**ALTERATION TO A HISTORIC PROPERTY STAFF REPORT**

Site:	53 Columbus Avenue	c.1874 Second Empire House
Case:	HPC 2015.008	Columbus Ave. / Warren Ave. Local Historic District
Applicant Name:	RCG Columbus Renewal LLC, Owner	
Applicant Address:	17 Ivaloo Street, Somerville, MA 02143	
Date of Application:	February 25, 2015	
Legal Notice:	<i>Alter rear ell and windows.</i>	
Staff Recommendation:	Certificate of Appropriateness	
Date of Public Hearing:	March 17, 2015

*53 Columbus Avenue rear 3-25-2015*

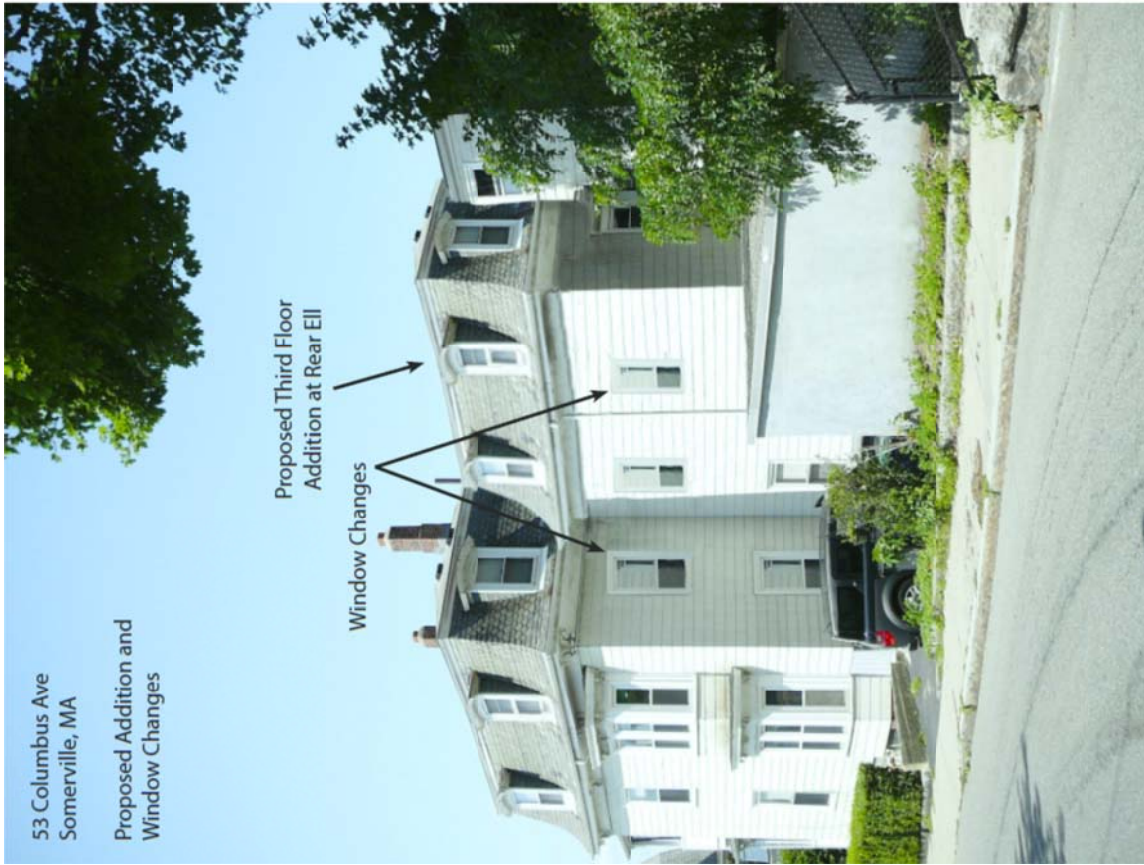
The building is a Second Empire located at the corner of the Prospect Hill Parkway and Columbus Avenue. The rear ell has a small secondary third floor addition leading to covered egress stairs adjacent to Prospect Hill Park. The addition is set back from the rear ell to the width of the egress stairs. It cuts into one of the dormer windows and has 4 small vinyl windows. The siding on the addition is 3 tab asphalt roofing shingles. The roof line is about 6 inches lower than the break on the Mansard roof. It may have been added to the building in 1945 when the stairs were added. The building has asbestos cementitious shingled siding on most of its body.

The windows on the second floor rear and side have been altered. They are both shorter and wider than traditional windows. The third floor windows are considerably smaller.

53 Columbus Ave  
Somerville, MA  
Proposed Roof Plan

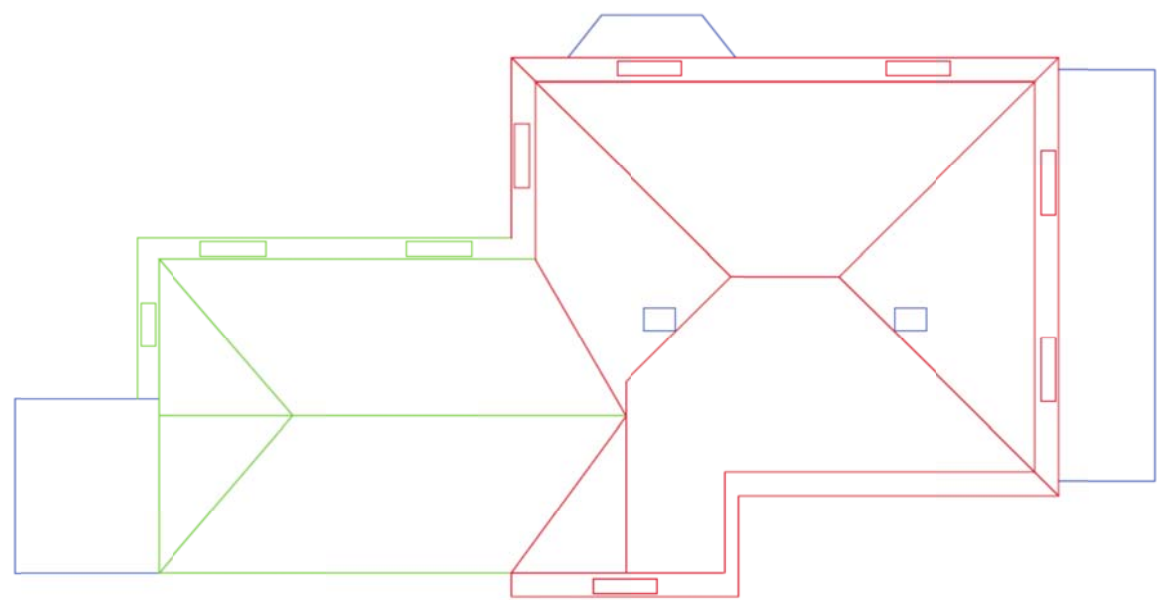
The proposal will continue the ell upward to meet the eave line of the Mansard roof and then replicate the roof on two sides with arched dormer windows to match the existing on the sides

The lower eave line of the Mansard would be continued on the opposite side of the house. The roof would be a shallow gable. The siding will be cementitious shingles that would blend with the existing asbestos shingles.

There will be no alteration of the original Mansard roof shape however some of it will be lost due to the expanded the third floor addition on the ell incorporating part of it. The ell addition will be altered to match the original roof height, eaves and form.

No original architectural details will be removed beyond those necessary to enlarge the ell addition. Architectural details such as the eave trim and break details found on the original roof will be replicated on the ell addition including the dormers.

1. The roof shall follow the same eave line and roof break.
2. The planes of the roof shall be the match the curvature of the existing.
3. The eave details and break in the Mansard shall match the existing in design, material, and proportions
4. The dormers shall match the existing in design, material, and placement
5. The window casings should match the originals in size, shape, form and design.
6. The window openings shall match the original openings found on the front and sides of the building.
7. The window sash shall match the existing in form and style.
8. The siding on the walls shall be cementitious shingles to match the existing in size, shape, texture and color.
